RE: GRADING & DRAINAGE PLAN FOR SUNSET VILLA (K-12/D3)
RECEIVED SEPTEMBER 16, 1996 FOR PRELIMINARY PLAT
ENGINEER'S STAMP DATED 8/14/96

Based on the information included in the submittal referenced above, City Hydrology accepts the grading & drainage plan for preliminary plat. The following comments must be addressed before Final Plat:

TITLE: **DRAINAGE & GRADING PLAN**

PROJECT **SUNSET VILLA SUBDIVISION**

TYPICAL LOT DRAINAGE

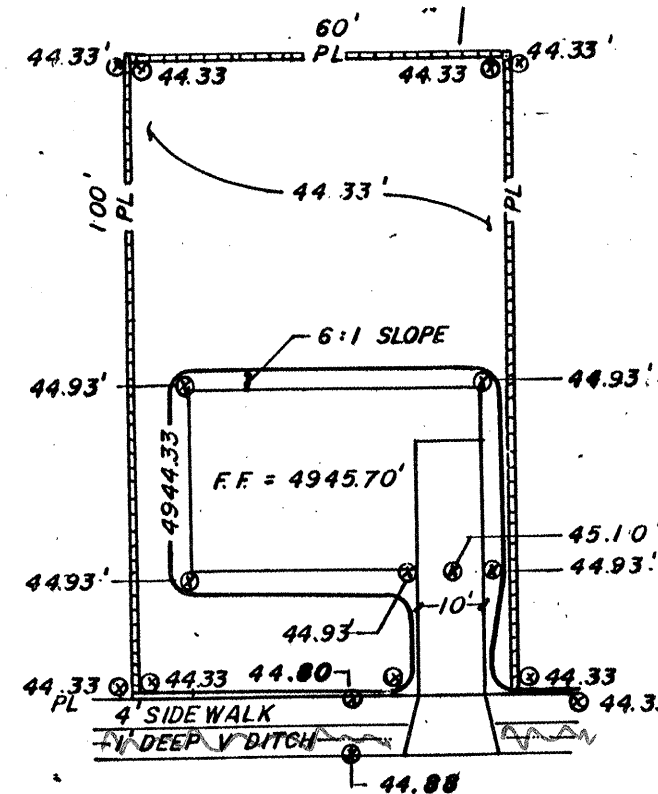
Remove the 1' deep V ditch from the "Typical Lot Drainage". Even though the "flat grading" criteria has been formalized, a Private Facilities Drainage Covenant is still required to inform the home owners of their responsibilities.
